SUBJECT: Forwards copies of responses to NRC 780918 ltr requesting
 addl info re Instrumentation & Controls Sys. Responses to
 be formally inserted in FSAR as an Amend in Feb 1979.
(see reports)

G02-79-04
January 5, 1979

Subject: WPPSS NUCLEAR PROJECT NO. 2
RESPONSES TO INSTRUMENTATION AND CONTROL
BRANCH, REACTOR SYSTEMS BRANCH, AND
HYDROLOGY-METEOROLOGY BRANCH QUESTIONS

CONTAINMENT (DRYWELL/WETWELL) VACUUM BREAKER CONTROL LOGIC DIAGRAM

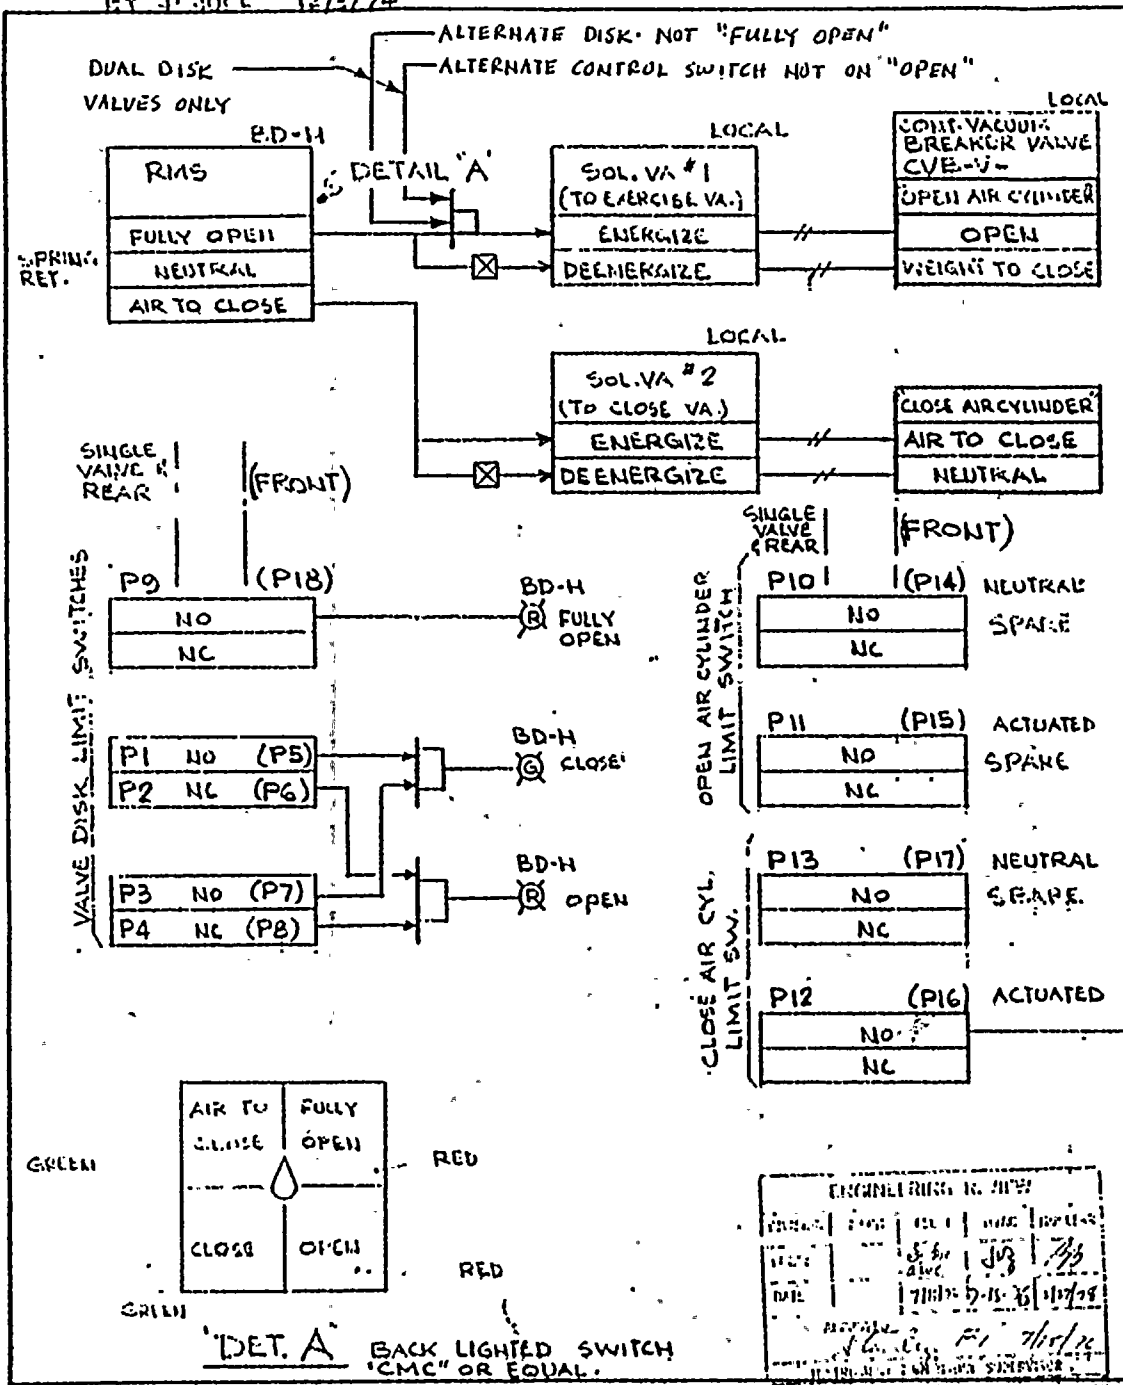
Your response to Item 031.001(p) is incomplete. Describe the air supply, pressure control, and position indication for the butterfly valves in accordance with the guidance provided in Section 7.3.1 of Regulatory Guide 1.70. Clarify the reference to 6.2.1.1.2 in the response to Item 031.001(p) since this response does not address the staff's concern regarding the position indication instrumentation.

This part to be modified to show air supply and solenoid pilot valves for vacuum breaker valves CSP-V-7, 8, 10 also.

Each butterfly valve is air-operated to close. During normal plant operation each valve is maintained in a closed position by means of control air supply through a 3-way solenoid pilot valve. The plant control air supply system is backed up by a Quality Class I air supply system (see Figure 3.8-56). Upon venting of air from the air-operators, the butterfly valves are spring-actuated to open. This is accomplished through remote manual deenergization of the solenoid pilot valve, or by a signal from the differential pressure switch which deenergizes the solenoid pilot valve when the secondary containment atmospheric pressure is more than 0.5 psi greater than the suppression chamber atmospheric pressure.

Two limit switches, wired to indicator lights in the control room, are provided with each butterfly valve for position indication. One switch actuates when the valve is fully open, and provides an alarm and "open" visual indication in the control room. The other switch actuates when the valve is fully closed, and provides a "closed" visual indication in the control room. See Figure 3.8-57 for an illustration of the logic, controls, and position indication for the butterfly valves.

In series with each butterfly valve is a single disk check valve. The disk is maintained in the closed position during normal operation by means of a spring actuated lever arm and magnets embedded in the periphery of the disk. The magnetic and spring forces are overcome, and the disk opens when the pressure differential across the valve ~~exceeds 0.2 psi~~. The disk is fully open when the pressure difference is 0.5 psi. In addition, air cylinders are provided for remote operation of the disk. Compressed air is supplied by the plant control air system. Each disk has two air cylinders, one to open and one to close the disk. Each air cylinder is actuated through energization of a 3-way solenoid pilot valve. The two solenoid pilot valves associated with each disk are operated by a remote manual switch in the control room. During normal operation the remote manual switches are in the neutral position and the solenoids are deenergized. Each valve disk is provided with ~~three~~ ^{two} limit switches for position indication. Contact probes for ~~two~~ ^{four} of the ~~limit switches~~ are mounted ^{180°} ~~180°~~ apart on the disk face, and are wired to indicator lights in the control room to provide open and closed position indication. The ~~third limit switch~~ ^{fourth} also wired to a light in the control room, indicates when the disk is fully open. See Figure 3.8-58 for an illustration of the controls and position indication for the vacuum breaker check valves.

FIGURE
6.2-17a

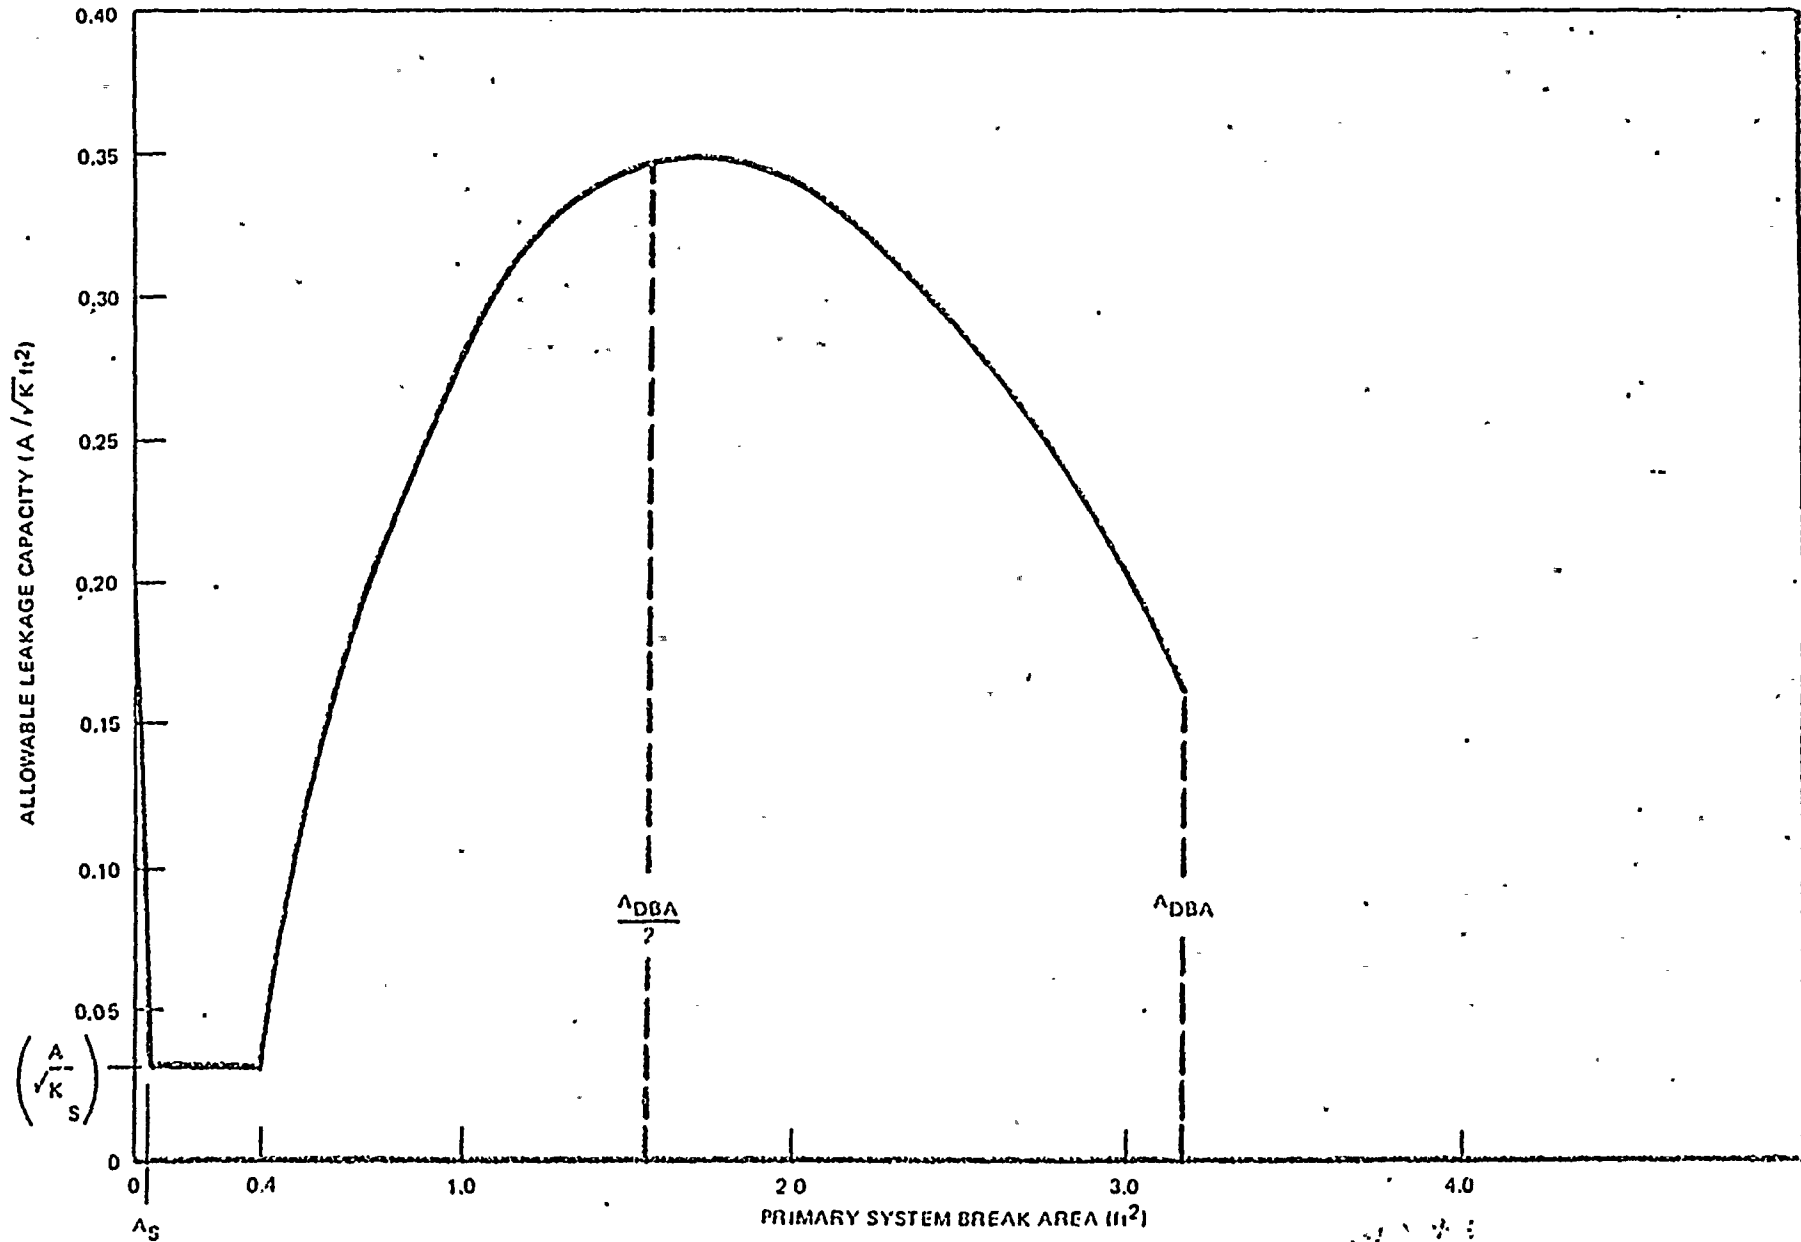
We require your compliance with our proposed position on containment steam bypass for small breaks. The details are contained in the Containment Systems Branch Technical Position, "Steam Bypass for Mark II Containments," a copy of which is enclosed.

The containment has been analyzed to determine the allowable leakage between the drywell and suppression chamber. Figure 6.2-17a shows the allowable leakage capacity (A/\sqrt{K}) as a function of primary system break area. A is the area of the leakage flow path and K is the total geometric loss coefficient associated with the leakage flow path.

Figure 6.2-17a is a composite of two curves. If the break area is greater than approximately 0.4 square feet, natural reactor depressurization will rapidly terminate the transient. For break areas less than 0.4 square feet, however, continued reactor blowdown limits the allowable leakage to small values. The maximum allowable leakage capacity is at $A/\sqrt{K} = .026$ square feet. Since a typical geometric loss factor would be three or greater, the maximum allowable flow path would be about .052 square feet. This corresponds to a 3 inch line size.
